Prepared by Kyle Taylor	Aircraft Make / Model (multiple)	Float / Ski Model Amphibious float models 3000A, 3450A, 6000A, and 8000A	Page 1 1
----------------------------	-------------------------------------	--	----------------

Title
Grease seal vent hole addition for main landing gear bearings

SERVICE LETTER No. 114

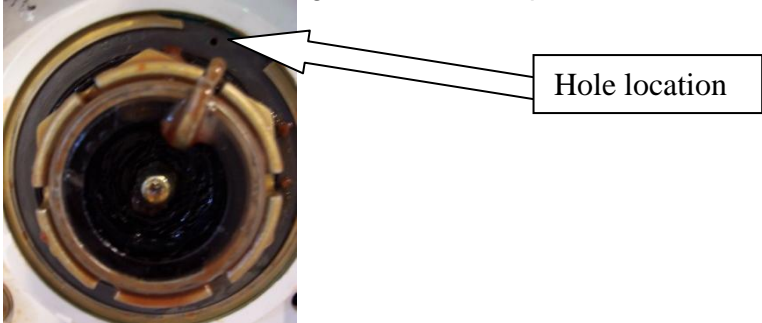
EFFECTIVITY	This service letter is effective for all float models listed above. Floats manufactured after approximately 2006 should already be equipped with this vent hole. An external visual inspection will quickly identify if a vent hole(s) are already installed.
COMPLIANCE	Compliance is optional for all aircraft equipped with the float models listed above.
BACKGROUND	A #50 drain hole has been added to the outboard wheel grease seal on the main landing gear for the affected float models. The hole was added such that grease has an escapement when the wheel axle grease fitting is serviced. Without the hole, and with over pressuring of the grease fitting, it is possible to blow out the grease seals. Addition of the hole improves wheel bearing life.
COMPLIANCE METHOD	<ol style="list-style-type: none"> 1. Remove wheel nut and cotter pin. 2. Remove wheel. 3. Remove snap ring and grease seal on the <i>side opposite from the brake caliper</i>. 4. Drill #50 hole in grease seal P/N 472469, located in the "O" of "National Oil" as printed on the seal. 5. Reinstall grease seal and snap ring. 6. Reinstall wheel, retaining nut, and cotter pin. <div style="text-align: center;">  </div>
